# UNITED STATES PATENT AND TRADEMARK OFFICE

<b>Office Action Summary</b>	<b>Application No.</b> 10/578,421	<b>Applicant(s)</b> KANG ET AL.
	<b>Examiner</b> DANIEL KENNY	<b>Art Unit</b> 3633

**DETAILED ACTION**

Annotated Fig. 4 (6,739,937)

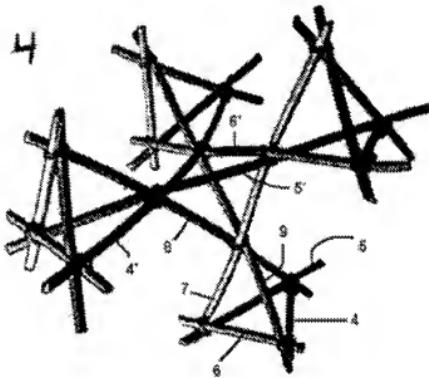
Snelson discloses a structure (Fig. 4 below) comprising:

*Claim 1 - a) a first tetrahedron member formed of a first to sixth wires, the first tetrahedron member being constructed in such a manner that the first wire (4), the second wire (5), and the third wire (6) are intercrossed in a plane to form a triangle, the fourth wire (7) is intercrossed with the intersection point of the second wire and the third wire, the fifth wire (8) is intercrossed with the intersection point of the first wire and the second wire, and the sixth wire is intercrossed with the intersection point of the third wire and the first wire, the fourth wire, the fifth wire, and the sixth wire (9) being intercrossed with one another at a single reference intersection point; and*

*b) a second tetrahedron member contacted with the first tetrahedron member at the reference intersection point and having a similar shape to the first tetrahedron member, the second tetrahedron member being constructed in such a manner that the fourth wire, the fifth wire, and the sixth wire pass the reference intersection point and extend further, each of a group of wires (4', 5', 6') is intercrossed with two wires*

selected from the extended fourth, fifth and sixth wires, the group of wires being in parallel with the first wire, the second wire, and the third wire respectively; and and the unit cell is repeated in a three-dimensional pattern, thereby forming a wire (or rod)-woven truss-type structure.
